AMENDMENT OF SOLICITATION / MODIFICATION OF CONTRACT				1. Contract Number	Page of Pages 1 3, plus attachments
2. Amendment/Modification Number A03	3. Effective Date See box 16	4. Requisition/Purchase Request No.	5. Solicitation Caption Infrastructure Improvements for 17 th Street, NE/SE

14. Description of Amendment/Modification (Organized by UCF Section headings, including solicitation/contract subject matter where feasible.)					
1. Bid Forms and Proposals, Pages 1-18 Schedule of Items are amended to replace the schedule of items with the attached schedule of items (pages 1R-18R) which incorporates the following items: <u>Line No.: 1620, 614744 – deleted and replaced with Line No: 0020, Item Description: 000506, 614744, F&I 215 WATTS LED</u> <u>Line No.: 1630, 614758 – deleted and replaced with Line No: 0030, Item Description: 000506, 614758, F&I 200 WATTS LED</u>

AMENDMENT OF SOLICITATION / MODIFICATION OF CONTRACT			1. Contract Number	Page of Pages
2. Amendment/Modification Number			3. Effective Date	4. Requisition/Purchase Request No.
A03	See Box 16			5. Solicitation Caption
			Infrastructure Improvements for 17 th Street NE/SE

CM-02

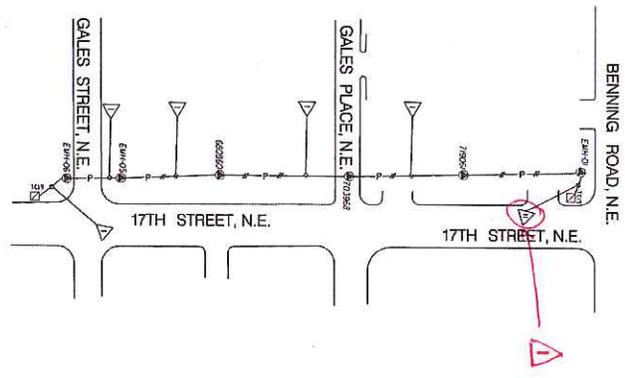
Question 6: “On drawing CM-02 there is a symbol that is not shown in the legend. Please identify or correct.”

Question 7: On Drawing CM-02 note 2 references TC18, but there is no TC18 shown on the drawings. Please correct.

Response to Question 6: See attached updated CM-02 for clarification.

Response to Question 7: See attached updated CM-02 for clarification.

RoadView LED R Series

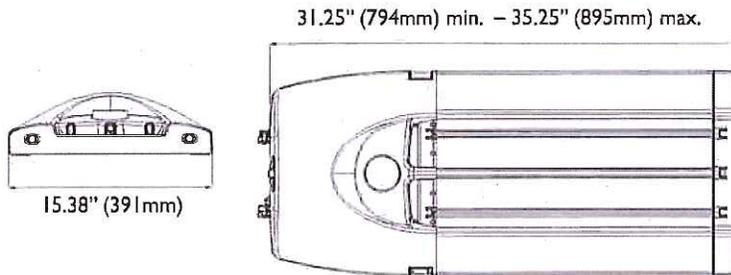
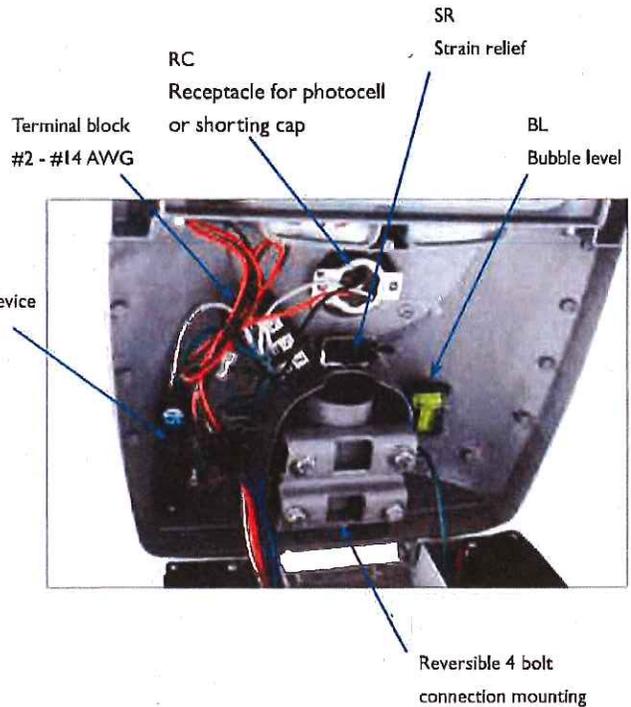
Question 3: “All fixtures are listed as 400W HPS. Will they be LED fixtures instead?”

Response to Question 3: See Schedule of Items, Page 1R, Items 0020 and 0030 for clarification.
